**MEHL Integrated Waste
Management Facility**

EPA Waste Licence Application
W0129-03. Response to EPA Article
16: Groundwater

Issue 1 | 16 October 2013

**Figure 5.
 Groundwater levels and contours:
 Namurian Formations
 8th July 2013**

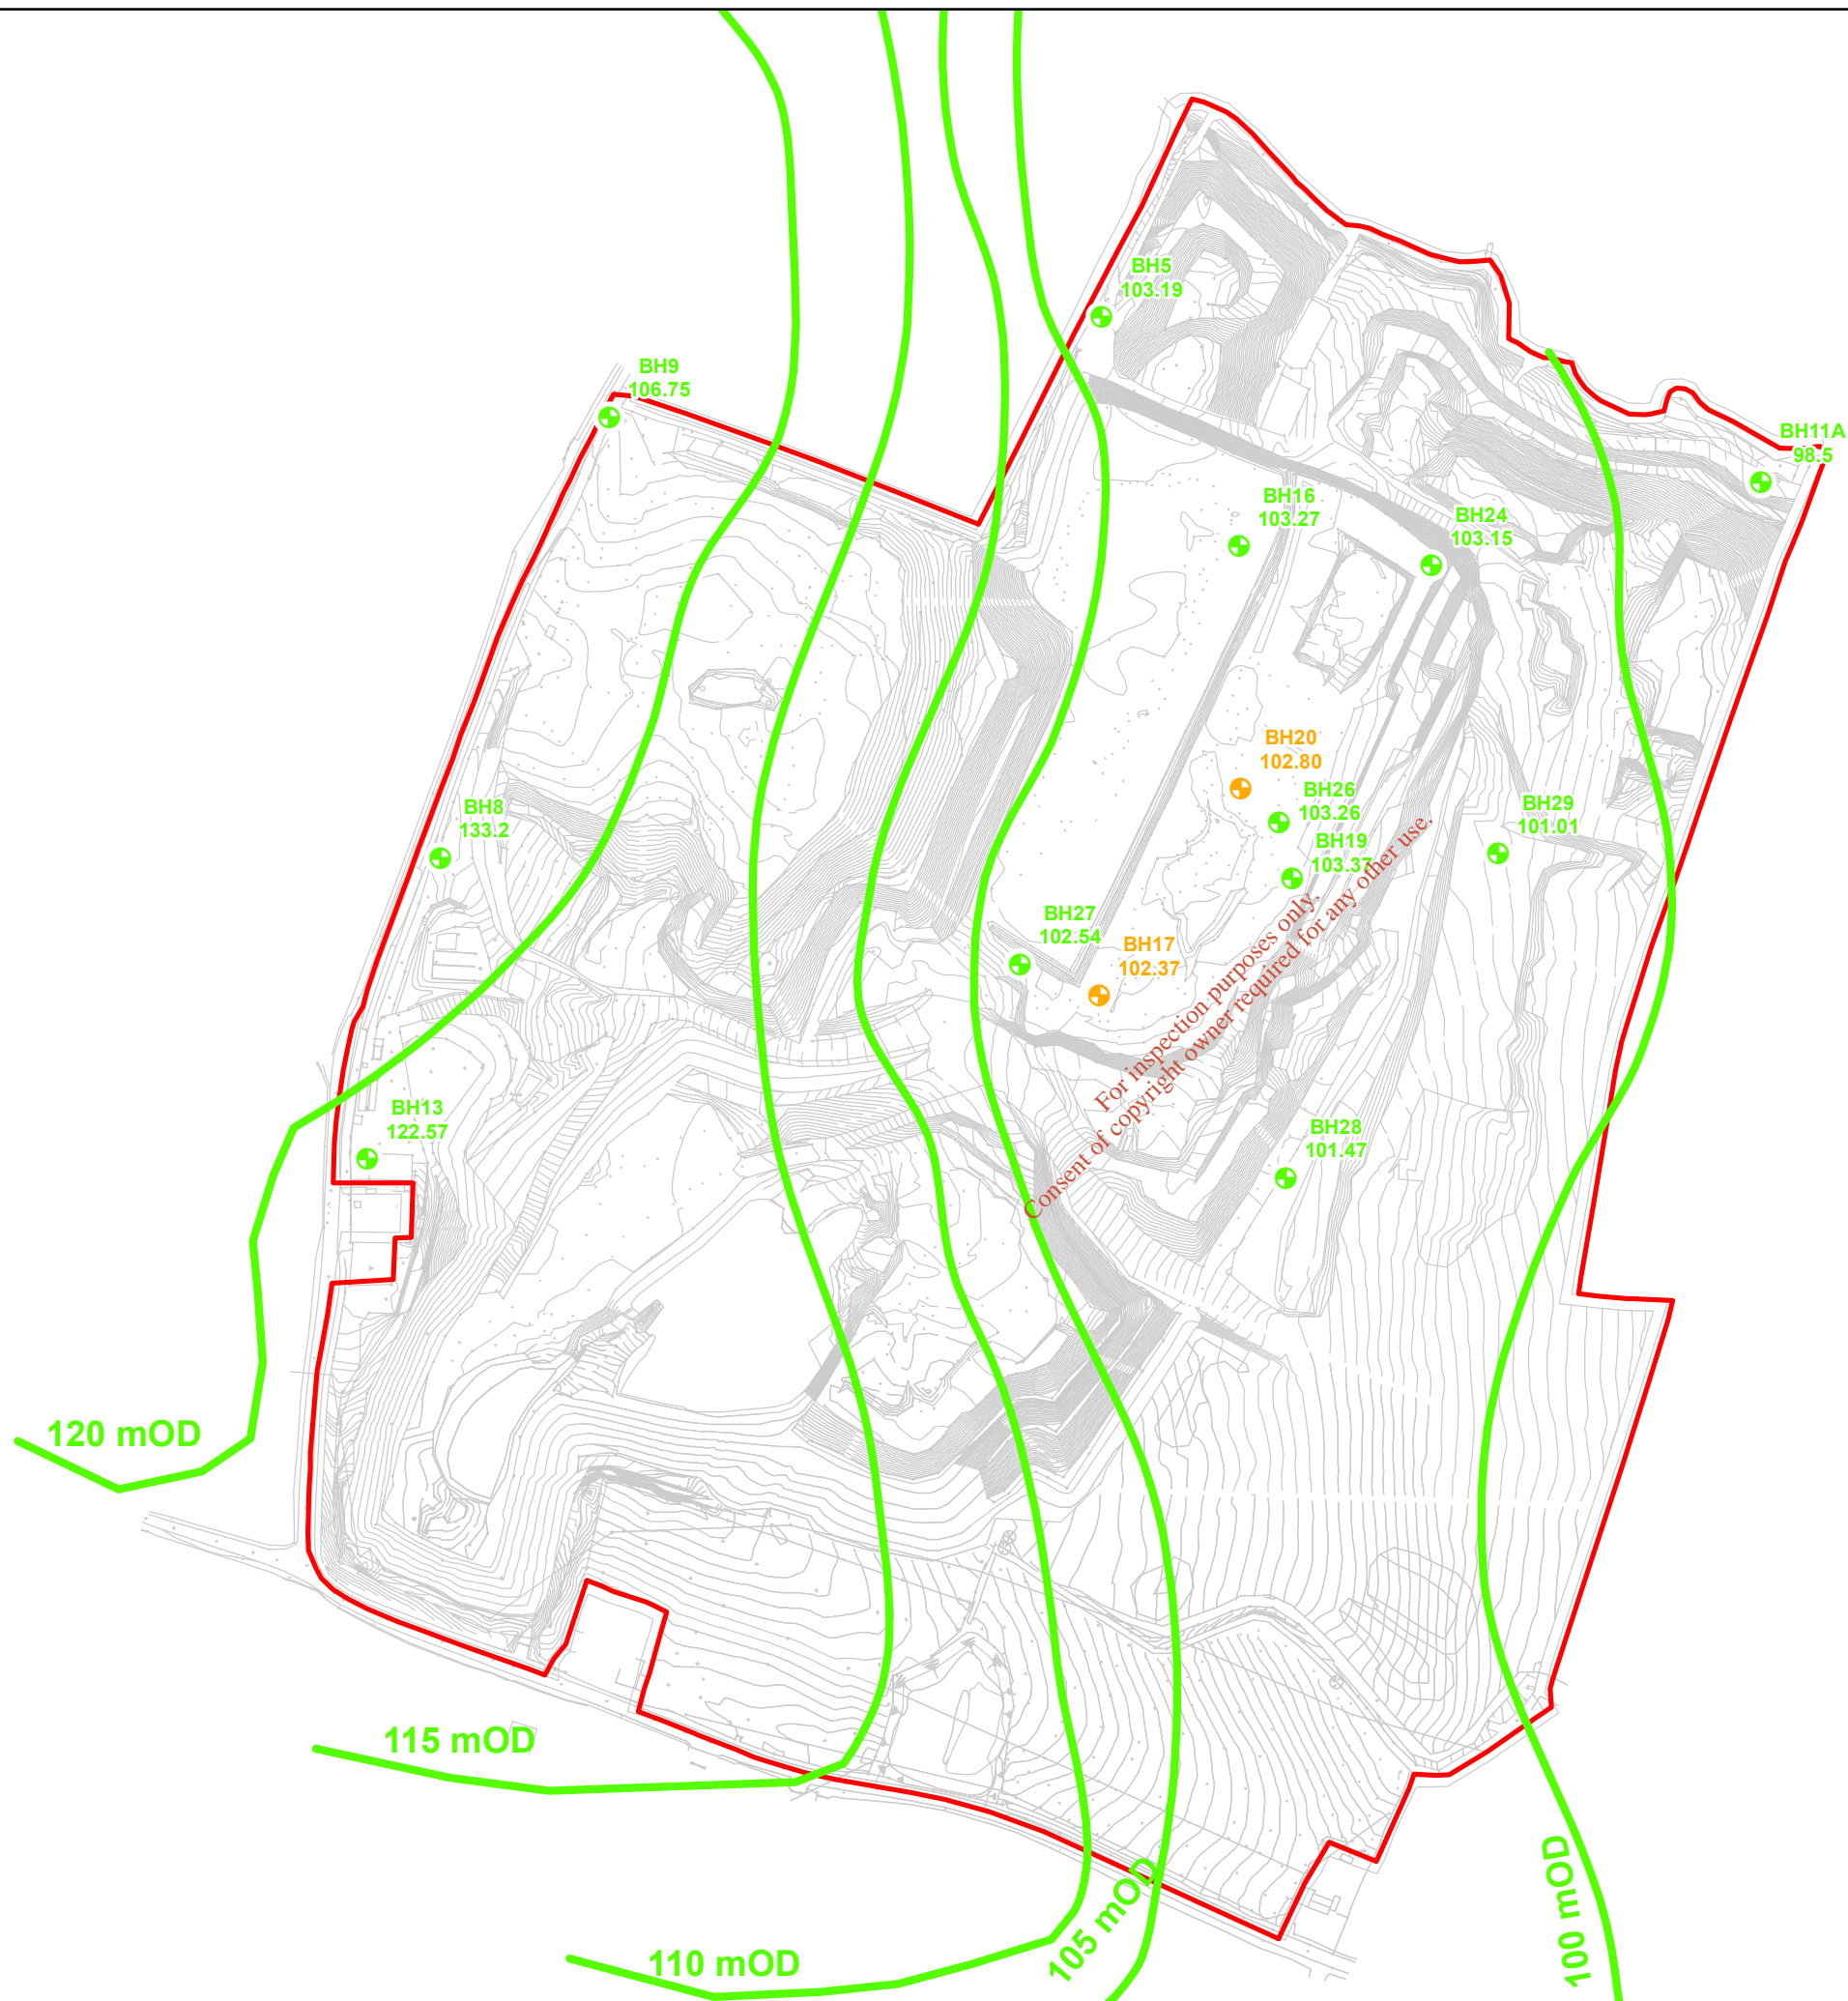
c) Two separate plans, one showing local groundwater piezometry in the Namurian Formation and one showing it in the Loughshinny Formation;

6.3. Provide separate figures showing the shallow (Namurian) and deeper (Loughshinny) groundwater flow regimes. Also present groundwater flow in a regional context on a detailed figure including site and off-site data, householder/farm wells and the Bog of the Ring water supply wells and trial wells (Figure 12 of the Hydrogeological Quantitative Risk Assessment only shows the local site groundwater flow regime).

- **Figure 4:** Groundwater levels measured in the Loughshinny Formation
- **Figure 5:** Groundwater levels measured in the Namurian strata.
- **Figure 6:** Groundwater contours for both the Visean and Namurian strata

- **Figure 3:** Regional groundwater flow regime
- **Figure 4:** Groundwater levels measured in the Visean strata (Loughshinny Formation)
- **Figure 5:** Groundwater levels measured in the Namurian strata.
- **Figure 6:** Groundwater flow in both Namurian and Loughshinny formations

**Figure 7.
Geological cross sections**

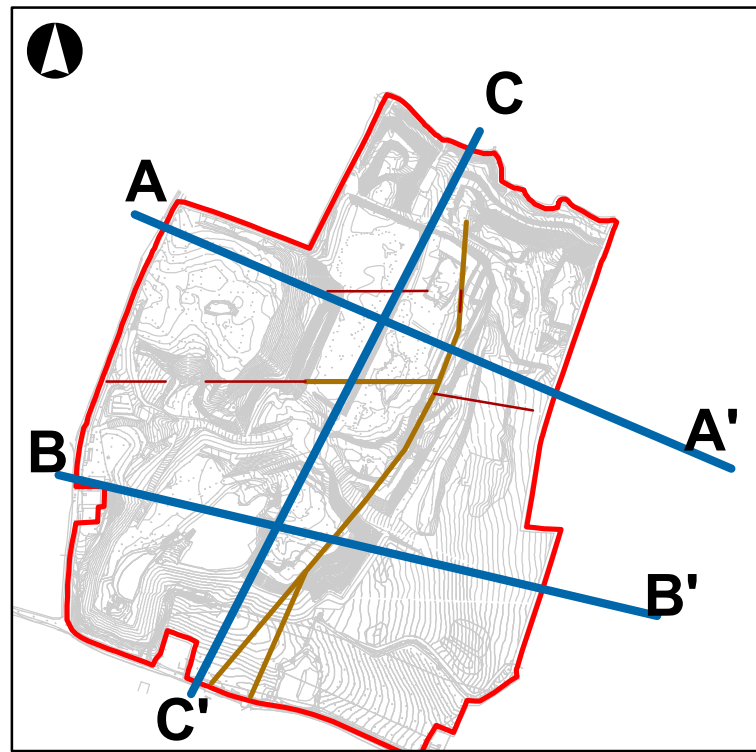
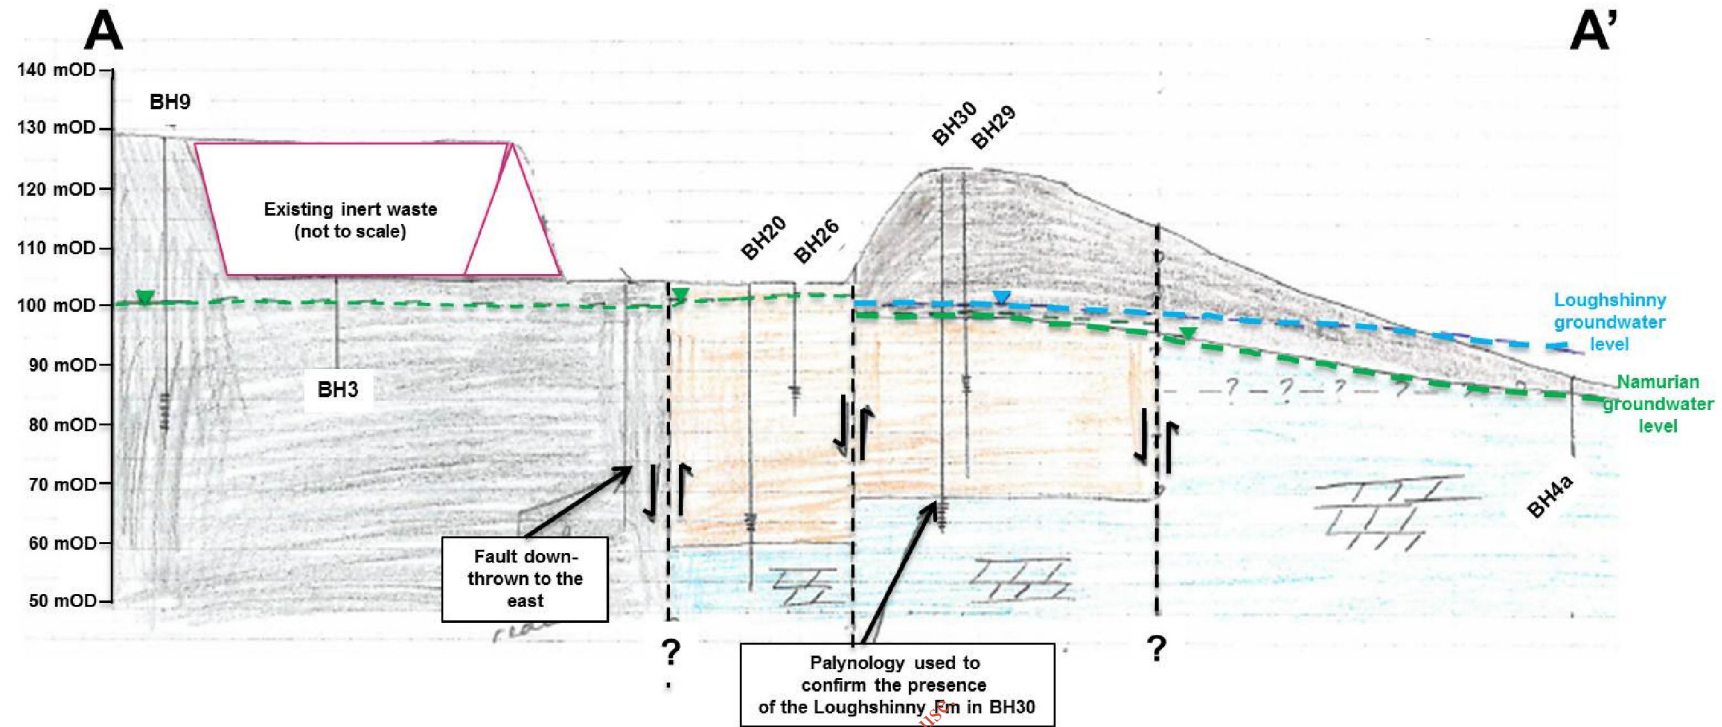
d) A series of cross-sections (e.g. one N-S through the proposed waste cells, and two E-W through the proposed waste cells) that accurately show the geology derived from borehole logs and head gradients derived from monitored water levels in boreholes screened in different strata;

Cross-sections are presented in **Figure 7**. These cross sections were constructed based on information from the borehole logs, down-hole geophysics, palynology, micropaleontology and the pumping tests. In some cases the borehole logs indicate uncertainty regarding which lithology was encountered, palynology, micropaleontology and the down-hole geophysics were used to aid the interpretation.
